Subject: Loose squeegee hose connection

Models Affected:

- Adphibian (all models)
- AX651 (all models)

ECO# : A-03856

Fig 1-

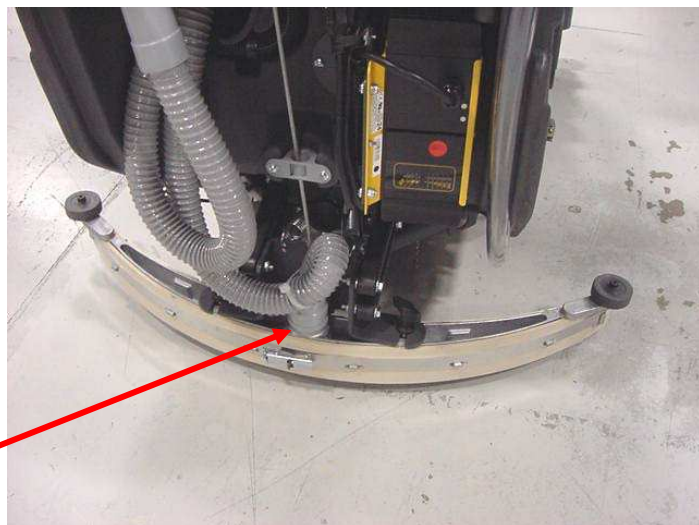
Issue: Poor water pick-up

Cause: Cuff on squeegee hose does not fit tightly with tube portion of squeegee casting 56314325.

Hose cuff does not fit tightly onto neck of squeegee casting

On machines with SN's prior to those noted below contact Technical Service at 800-989-2235 or ustechserv@nilfisk-advance.com to order sleeve 56317167. Install as as shown in Fig's 2-4.

Fig 3-

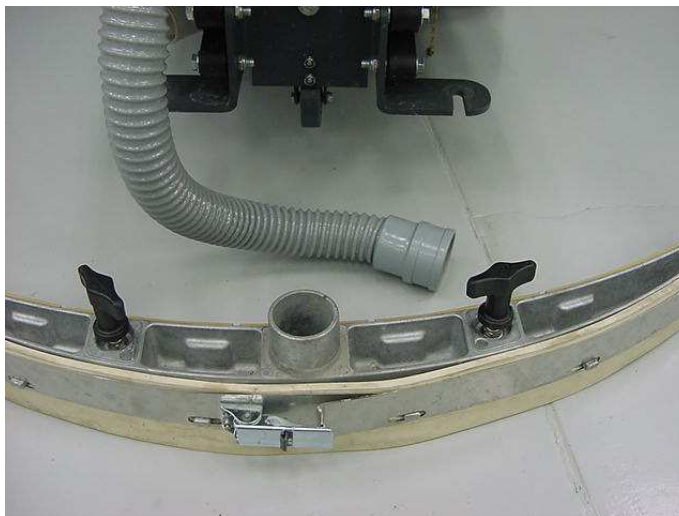
Install sleeve 56317167
over squeegee casting
tube end and press until
flush with top of tube.

Fig 4-

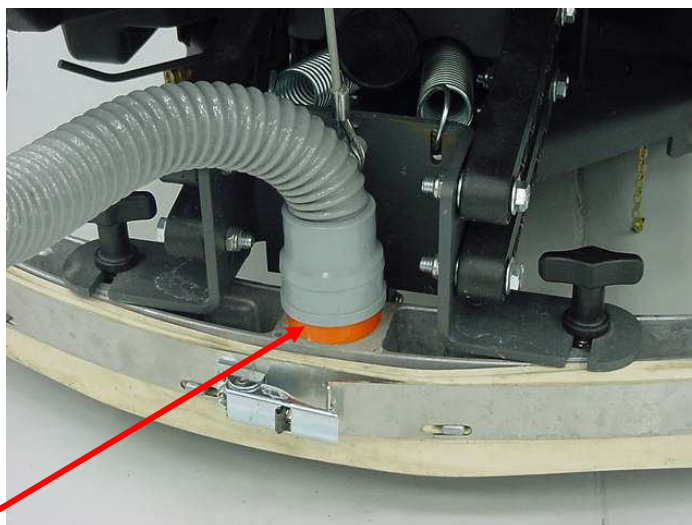
Reinstall squeegee and
squeegee hose
